**Proposed Rezoning From “AGR” & “GB” To “G/IC” for  
a Proposed “Social Welfare Facilities” (Residential Care Homes for The Elderly) (RCHE)  
Lot 232 RP, 232 S.A RP, 232 S.A ss. 1 to 14, 232 S.B RP, 232 S.B ss. 1 to 27,  
232 S.C to 232 S.E, 233 RP, 233 S.A to 233 S.M, 237 RP, 237 S.A to 237 S.R,  
239 RP, 239 S.A to 239 S.G in D.D.23, Tung Tsz, Tai Po, N.T.  
S12A Application for Planning Application No. Y/NE-TK/19  
Response-to-Comment – PlanD  
(Updated 17 June 2025)**

Comments	Response
<p><b>1. Comments of the Chief Town Planner/Urban Design and Landscape, Planning Department as follows:</b></p> <p>I refer to your the Further Information 3 (FI3) providing replacement pages of photomontages, revised Layout Plans, replacement pages of Supporting Planning Statement (SPS) and Responses-to-Comments (RtoC), etc. for the captioned application.</p> <p>Our comments/observations from urban design and visual impact perspectives are set out below.</p> <p><u>General Comments</u></p>	<p>Noted.</p>
<p>2. The application site (the Site) forms part of a vegetated land in the “AGR” zone interspersed with a few temporary structures, which is sandwiched between two clusters of village houses/low

G-02

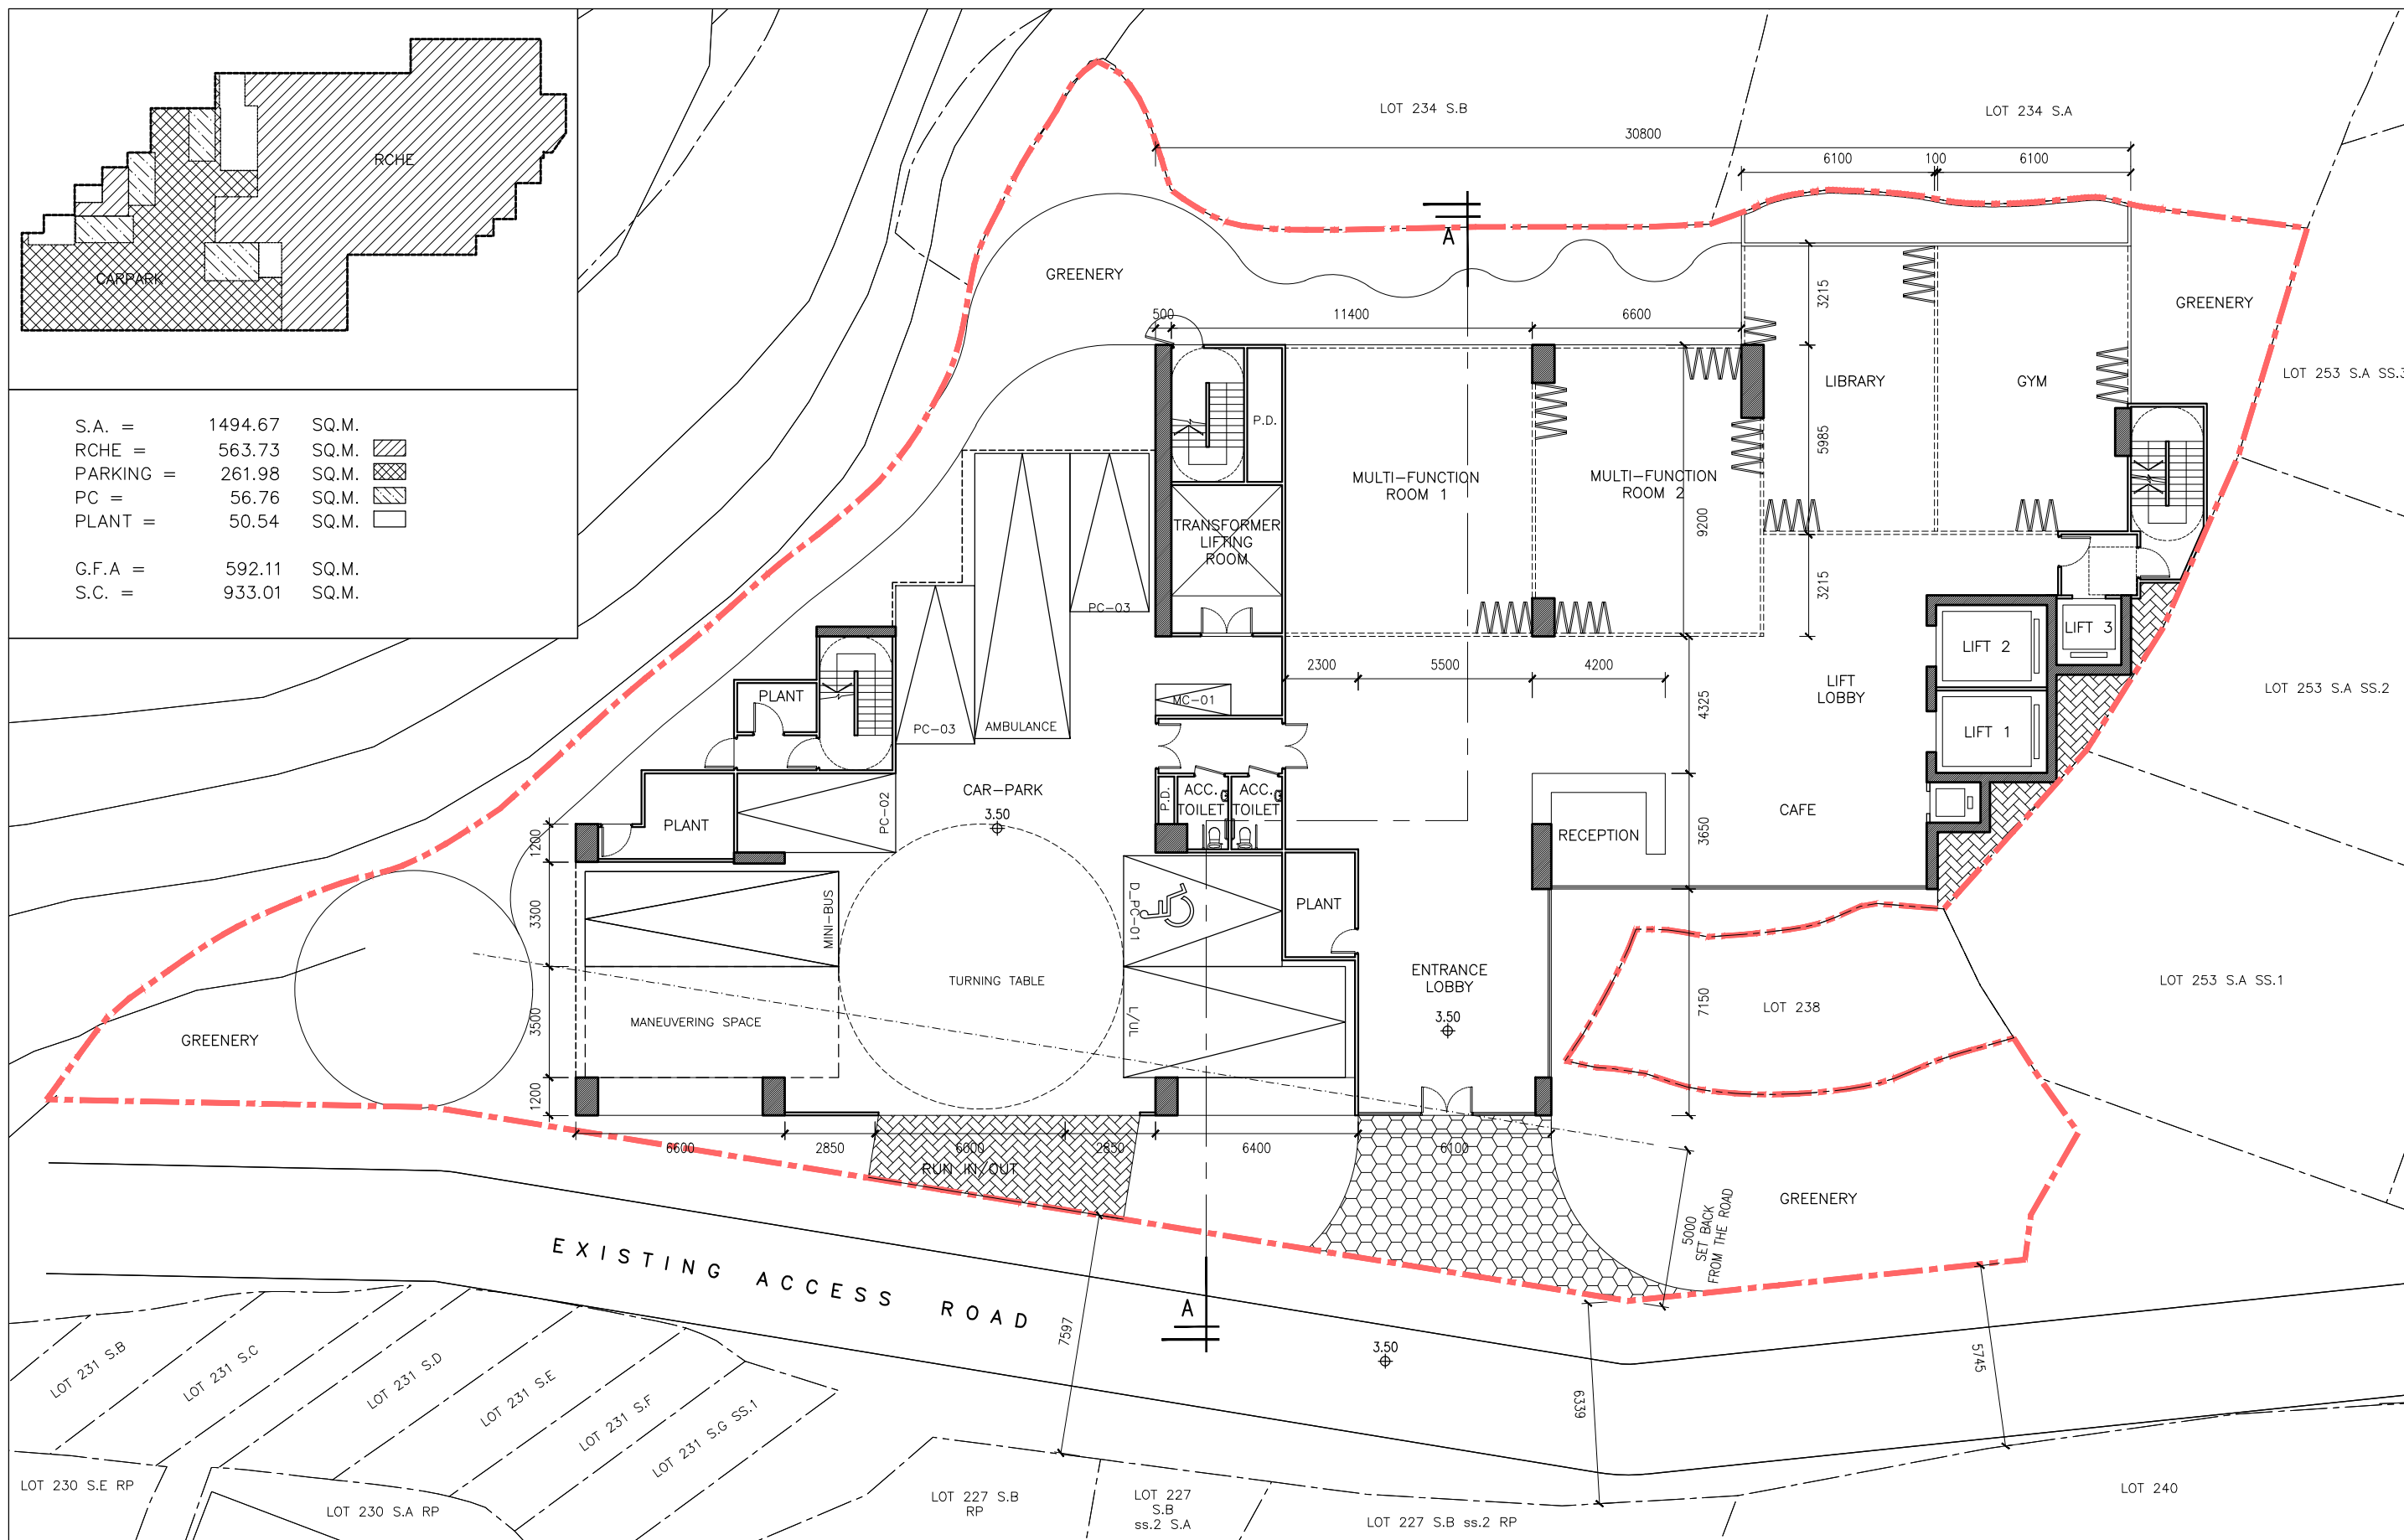
13	Please indicate the parking/loading/unloading area for emergency vehicles including ambulances.	Revised. Please refer to G-02. The loading/unloading is for both mini-bus and emergency vehicles.
14	The basic facilities in the RCHE shall include dining/sitting area. Please indicate on the layout plan if this is provided.	Revised. Please refer to G-04 to G-06.
15	According to para. 6.2 of the CoP, please ensure that the minimum area of floor space for each resident should be 9.5 sq m.	Confirmed.
16	Please confirm that all habitation area of the RCHE should be provided with openable/prescribed window(s). Furthermore, no part of the area used for habitation shall be more than 9 m, measured within the habitation area from the prescribed window(s).	Confirmed.
17	Please clarify if there is any rehabilitation area and indicate alternative arrangement(s) if this facility is not provided.	Tai Chi square and outdoor – exercise equipments in roof garden would be provided for rehabilitation.

G-04

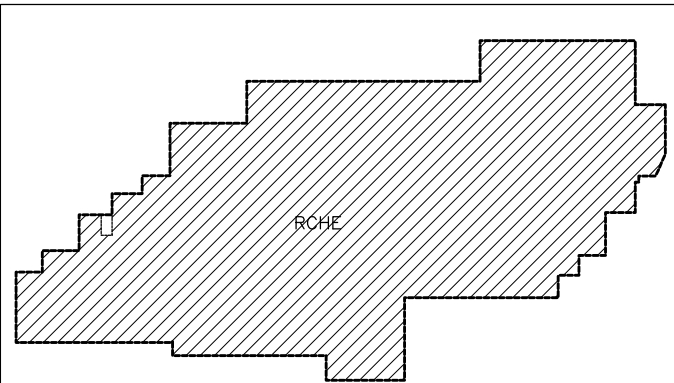
While the current design of the proposed RCHE, including the layout plan, clear width of every passage and doorway, etc., are considered at an initial stage, the applicant is required to submit the missing layout plan and make necessary changes/adjustments on its submitted design drawings so as to address our comments as set out above. We will offer further comments as and when appropriate.	Noted.
	<b>Comments from Licensing Perspective:</b>	
	Accessible toilets should be provided for every 50 bedspaces and on each floor of the proposed RCHE according to the para. 4.5.2 of the Code of Practice for Residential Care Homes (Elderly Persons). Accessible toilets were not shown on UG/F, Typical/F, 6/F & 7/F (drawing nos. G-03 to G06).	Accessible toilets are indicated on G-02 to G-06.
	Deadend travel distance and the total travel distance from any point of the proposed RCHE should not exceed 12m and 30m respectively. Deadend travel distance at some bed rooms in Dorm 9 on Typical /F plan (drawing no. G-04) and in suite 17 on 6/F plan (drawing no. G-05) might exceed 12m (Clause B11.2(b) in FS Code 2011 refers).	Revised. Please refer to G-04 to G-06.

For easy reference and comments, would the applicant please provide R-to-C in an Excel file consolidating comments and responses for all rounds.	
	<b>Licensing Perspective (RCHE)</b>	
	The applicant's response to LORCHE's previous comments on the revised layout plans is noted.	Noted.
	Additionally, please also note of the following new comment: Accessible toilets were found missing on 1/F & Typical/F plans (drawing nos. G04A & 04).	Revised accordingly.

G-05

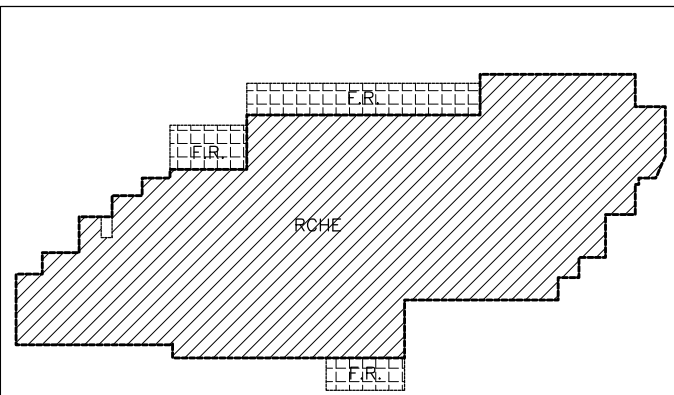
Item 4: No further comments.	
	Item 5: No further comments.	
	Item 6: No further comments.	
	Item 7: In the 2-bed suites on 6/F (layout plan G-05), the clear width of every passage and doorway shall not be less than 1050 mm and 800 mm respectively. Every passage and doorway shall be wide enough to accommodate residents using walking aids or wheelchairs. Please reexamine the design of these suites. Layout plan G-06 is not found in the FI. Please submit.	All suite are revised to 1 bed suite. Refer to G-05 to G-06.

G-06

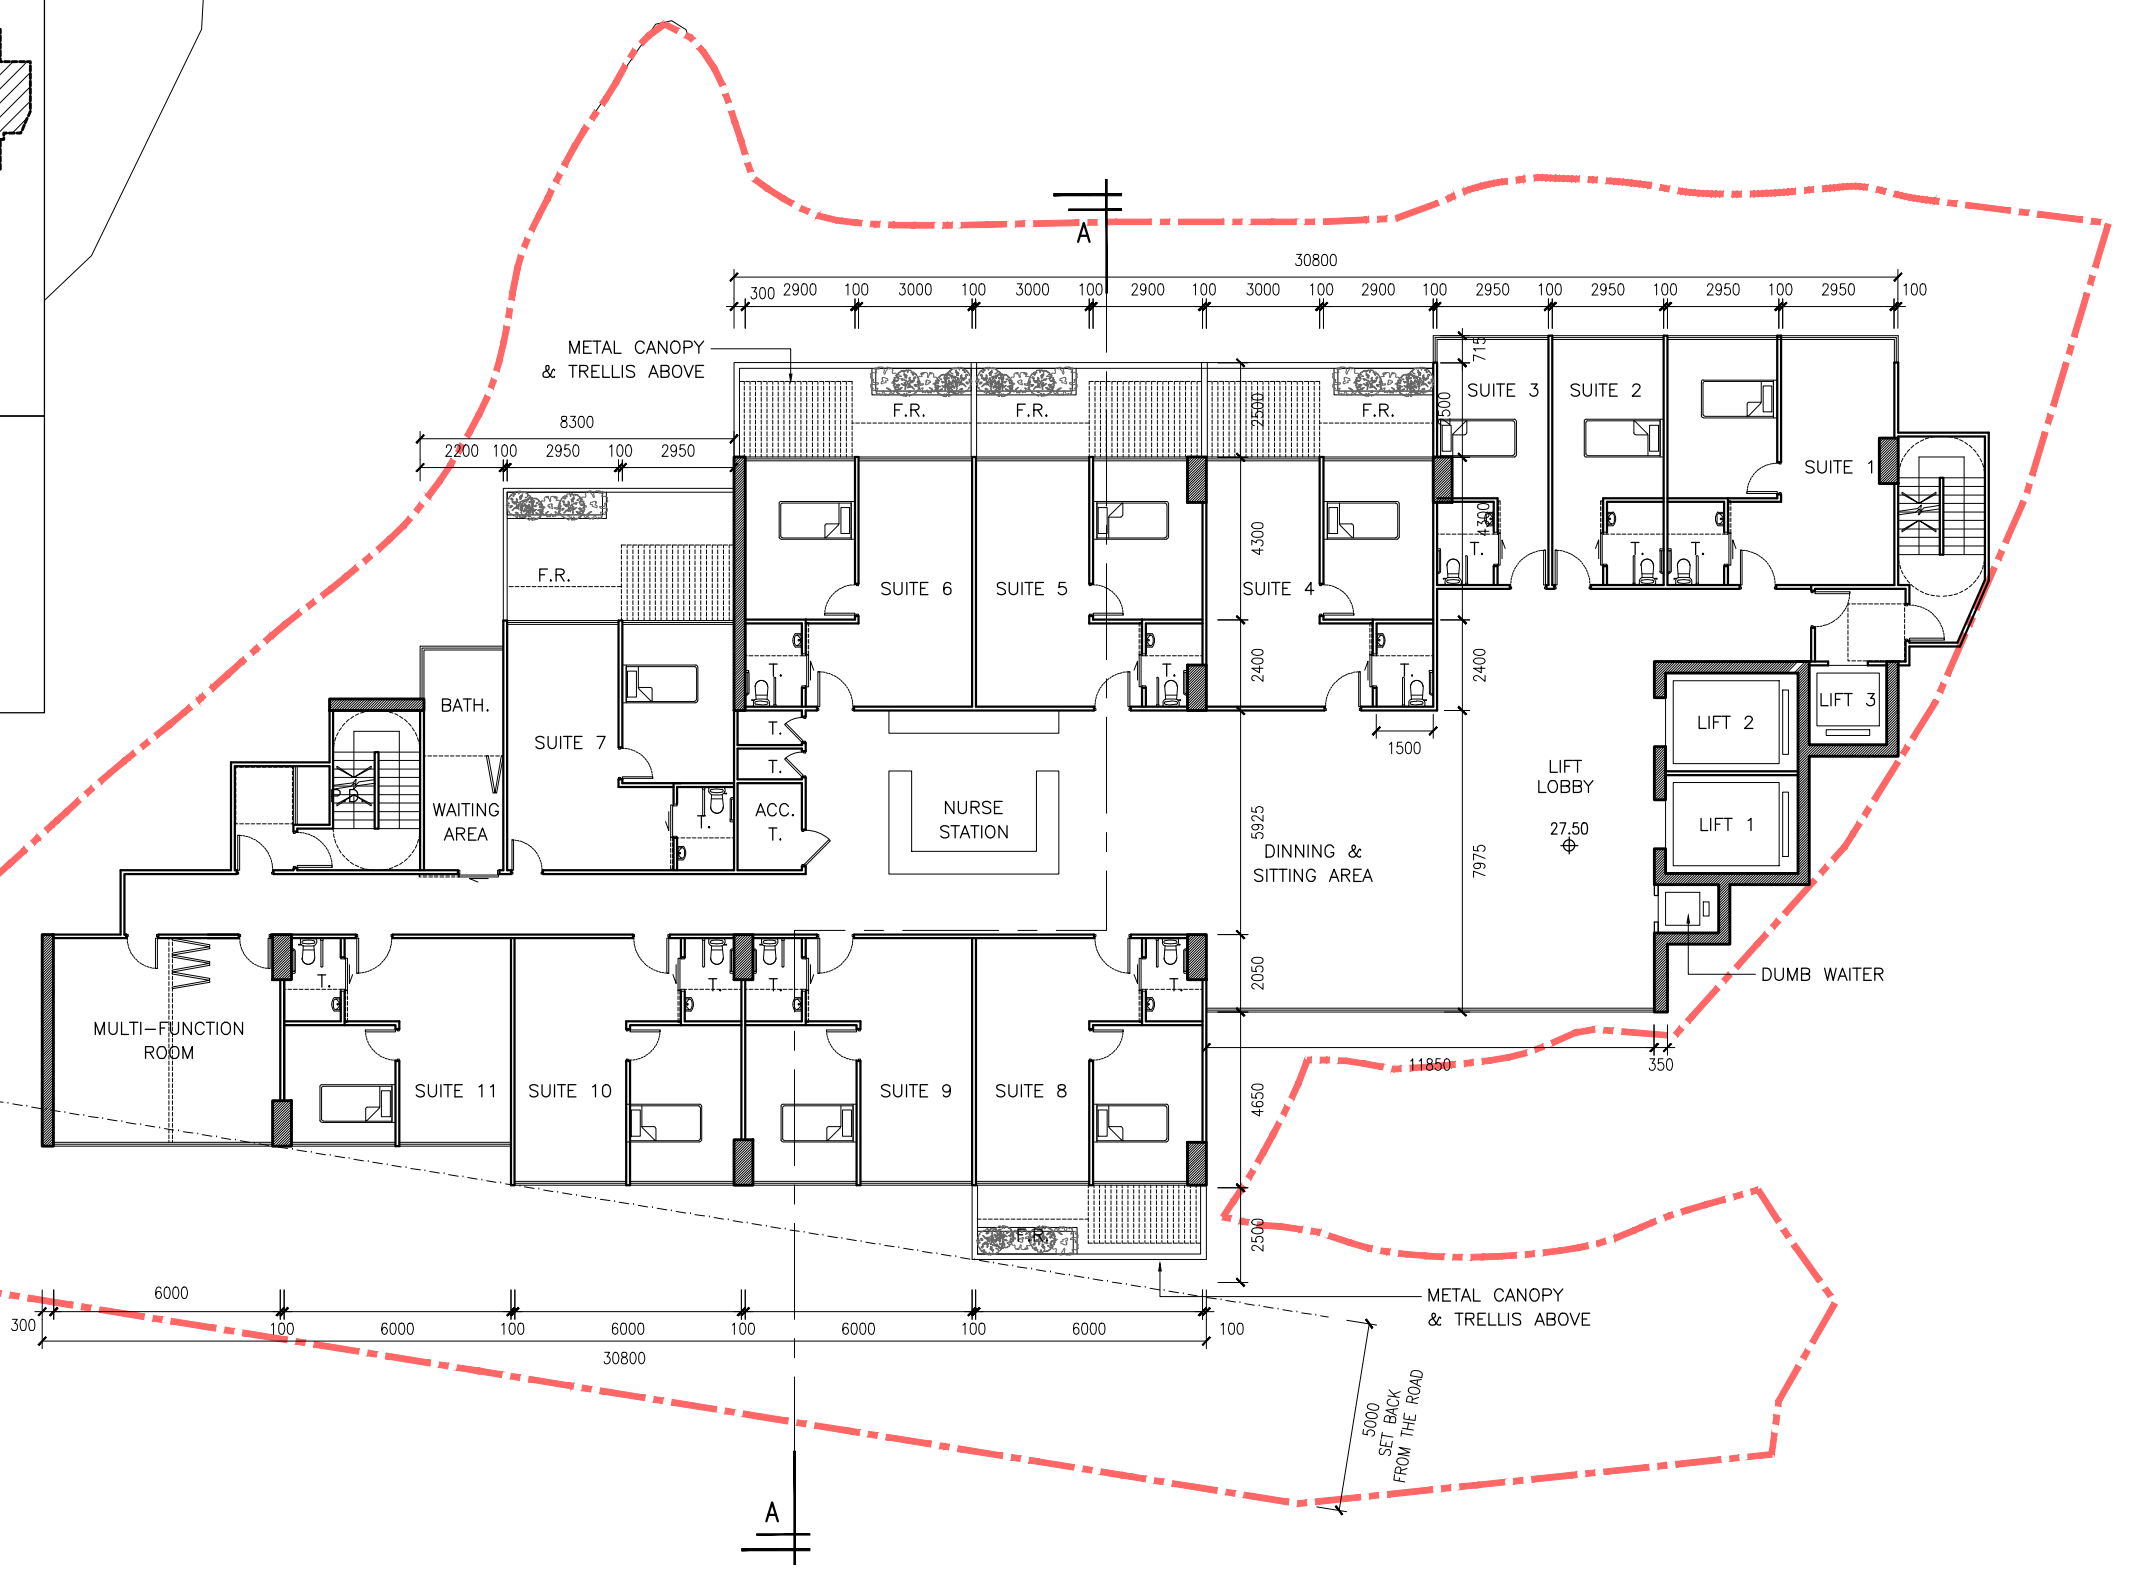
Item 12: No further comments.	
	Item 13: No further comments.	
	Item 14: G-06 is not found in the FI. Please submit.	Attached accordingly.
	Item 15: No further comments.

Item 18: Layout plan G-06 is not found in the further information. Please submit.	Attached accordingly.
	<b>Whether Premium Concession Scheme is applicable to the proposed RCHE</b>	
	No further comments.	
	<b>Any comments from the RCHE licensing perspective.</b>	
	This is deferred to any further comments from LORCHE.	
	<b>Any concerns on the local settings with no proper footpath along the local track leading to Ting Kok Road to access the Site and no public transport provision at the immediate surroundings of the Site.</b>	
	It is noted that proper footpath as shown in Figure 4 will be provided in the project. Such footpath should be in compliance with all prevailing legal and statutory requirements. This is deferred to the comments from Transport Department.	Noted.
	<b>Any other comments in relation to the provision of RCHE apart from the above.</b>	
	The applicant is required to provide a full set of amended/ updated layout plan in every round of submission.	Attached.

Re item 7, no further comments.	
	Re item 10, G-07 showed that 'canteen' is not yet revised to 'resting area'.	Revised accordingly.
	Re item 11, no further comments.	
	Re item 14, the design of toilet in Suite 7 on G-06 is not found.	Revised accordingly.
	Re item 17, for the roof garden on R/F is situated at a height more than 24 m above the ground floor, rehabilitation area to which residents have access to is not suggested to be provided on R/F.	Roof garden is opened to staff and visitors only.
	Re item 18, no further comments.	
	Re other comments on the full set of amended/updated layout plan: - G-04: Door is not found in Dorm 1,2,4,5,7,8,9; entrance/door is not found in Dorm 3,6; accessible toilet is not found. - G-04A: Door is not found in Dorm 1,2,4,5,6,7,8,9; entrance/door is not found in Dorm 3; accessible toilet is not found. Regarding the area/room marked in 'P.' near isolation room, please clarify/provide the full name of this area/room. - G-01: Please provide revised total number of beds of RCHE for residents, which does not include beds of staff quarters and isolation rooms.	Door added. Accessible toilet added. "P." refer to planter room. Different type of beds are listed on G-01.
